**SUNDRY NOTICES AND REPORTS ON WELLS**  
*Do not use this form for proposals to drill for or to re-enter an abandoned well. Use Form 3160-3 (APD) for such proposals.*

8. Well Name and No.  
**Jicarilla 464-30 #9**

# PLUG AND ABANDONMENT PROCEDURE

CONDITIONS OF APPROVAL

## Proposed P&A

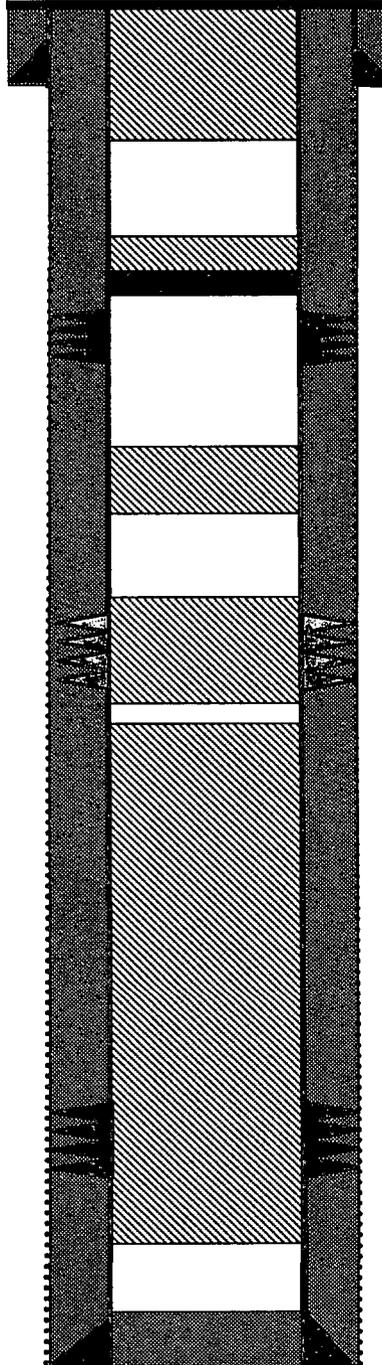
1. Plugging operations authorized are subject to the attached "General Requirements for Permanent Abandonment of Wells on Federal and Indian Lease."
2. Farmington Office is to be notified at least 24 hours before the plugging operations commence (505) 564-7750.
3. The following modifications to your plugging program are to be made:
  - a) Place the Nacimiento plug from 2178'- 2078'.
  - b) You are required to have H2S monitoring equipment and personnel on location during plugging operations.

You are also required to place cement excesses per 4.2 and 4.4 of the attached General Requirements.
